# CITY PLANNING COMMISSION

**APPLICATION:** Special Permit to allow a duplex in the Single Family Residential (R-1B) Zone.

**PROPOSAL:** The applicant is requesting the necessary entitlements to use an existing two story 1,850 square foot residence as a duplex.

P87-068

# SITE PLAN

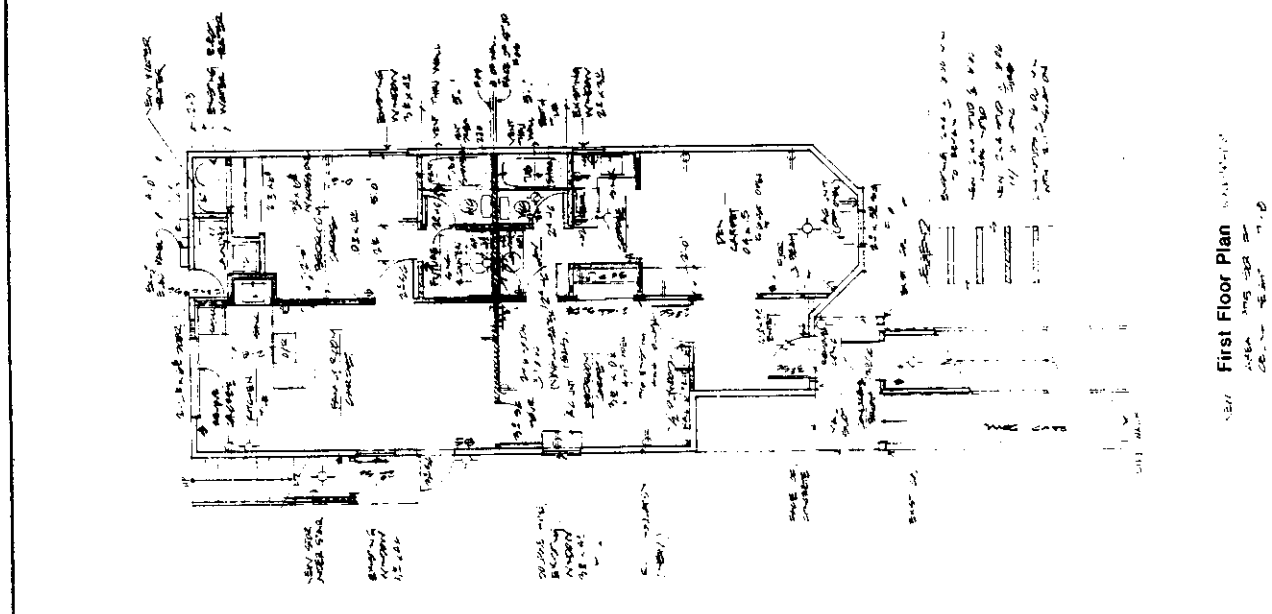
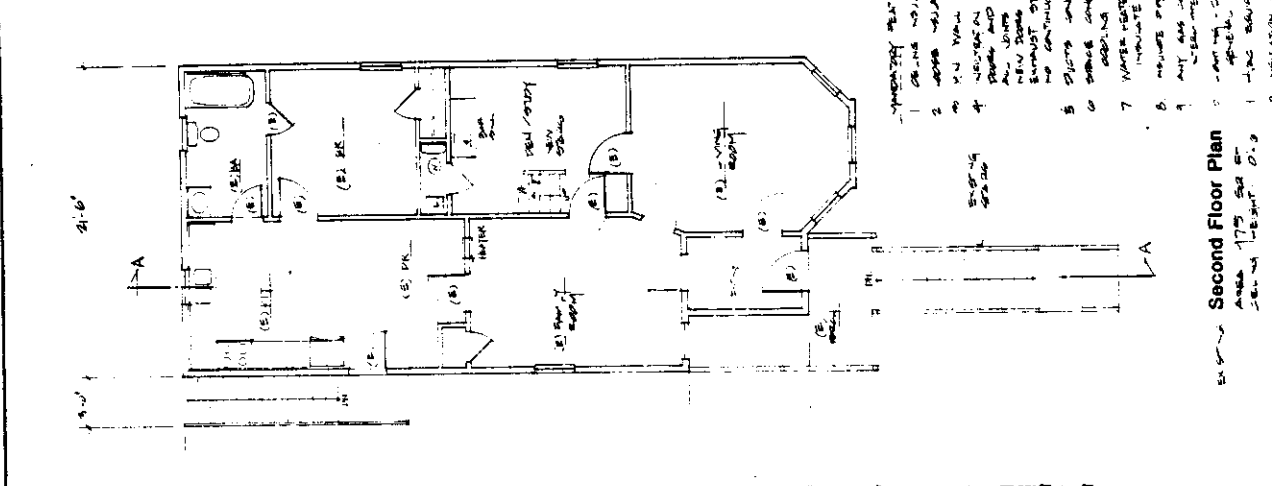
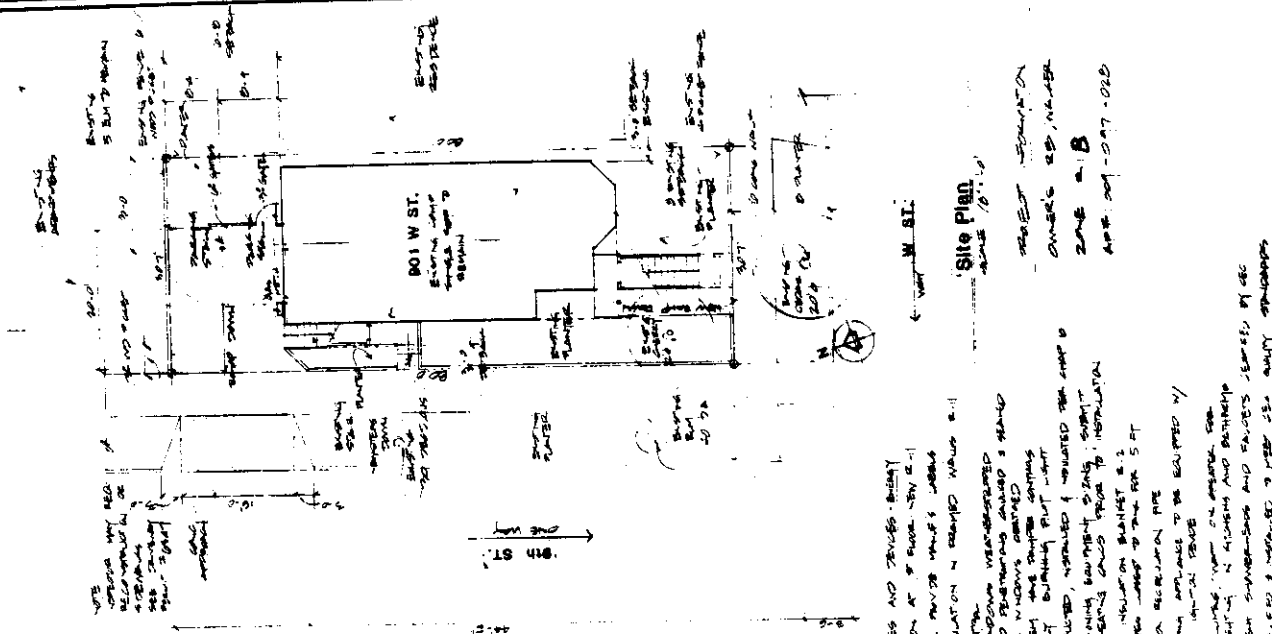
The applicant proposes to provide two on-site uncovered parking spaces located parallel and adjacent to the north property line. (See attached site plan.) The proposed parking area is presently graveled but not paved. The cars would park directly in front of two existing six foot high wood gates. The applicant has indicated these wood gates provide temporary security for the backyard and will be removed prior to completion of the duplex. In addition, the driveway will require a curb cut and driveway permit from the Public Works Department.

Staff recommends the proposed parking area be paved to provide a more permanent parking surface and conform to the current parking standards of the Zoning Ordinance. Two concrete wheel stops should be located two feet from the end of the parking stalls to prevent cars accidentally rolling into the back yard area. (See exhibit A.)

Entire parking surface must be flat (within 3 percent slope)

1. The entire parking surface must be flat (within 3% slope, as required by the City Traffic Engineer.
2. The parking surface shall be paved to the parking standards of the Zoning Ordinance.
3. Two concrete wheel stops, one for each parking stall or a continuous concrete curbing shall be placed two feet from the end of the parking stalls.
4. The applicant shall obtain a driveway permit from Traffic Engineering for the proposed driveway.

# FLOOR PLANS

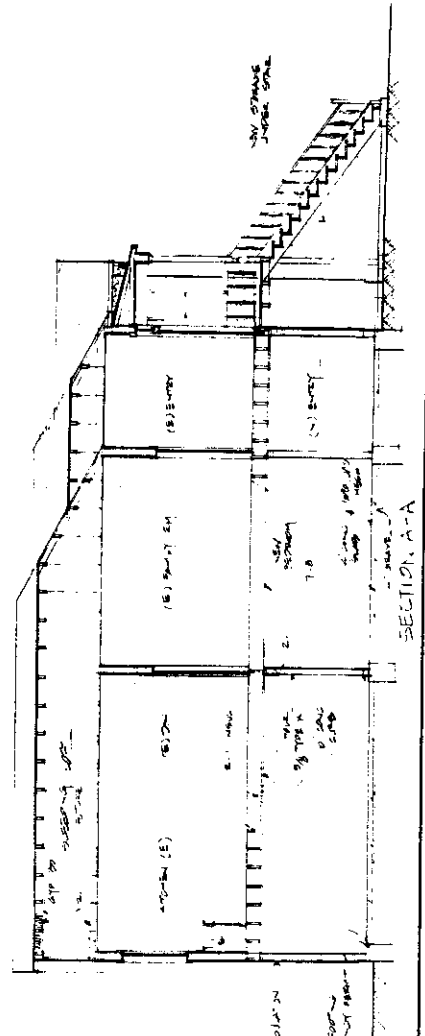
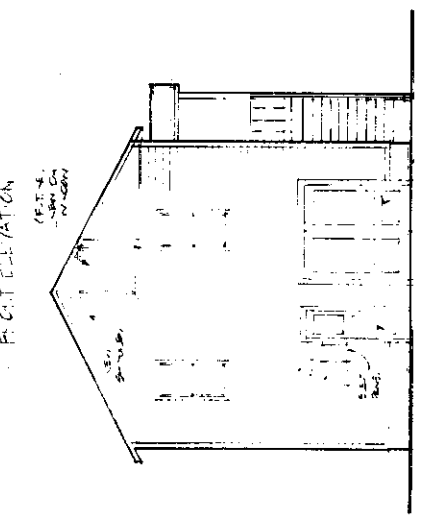
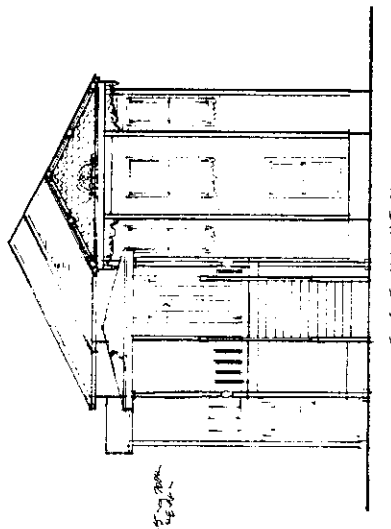
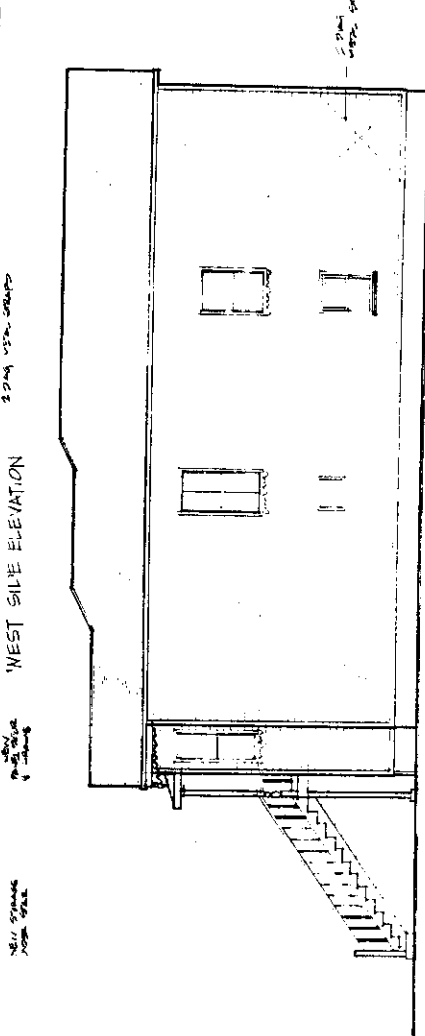
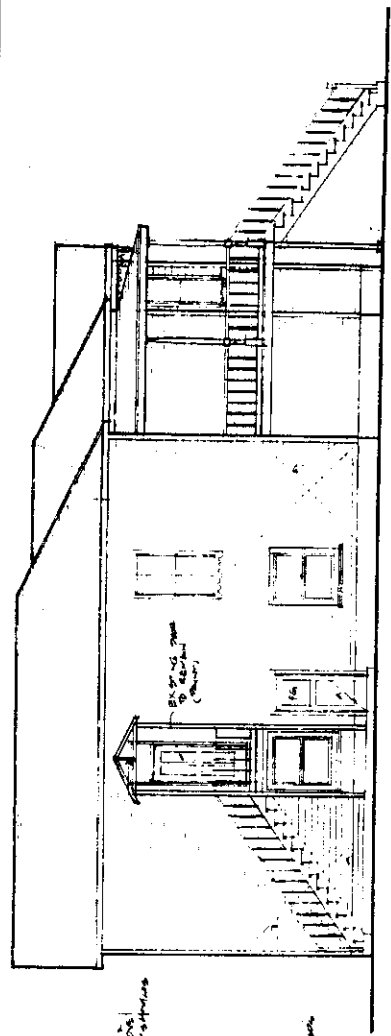
Floor plans submitted show two bedrooms located on the first floor and one bedroom on the second floor. A loft area above the second floor is proposed for a future sleeping area, den and bathroom. The applicant should be aware the Zoning Ordinance does not allow the loft to be converted to a third unit. The R-1B zone allows a maximum of two units on a parcel.
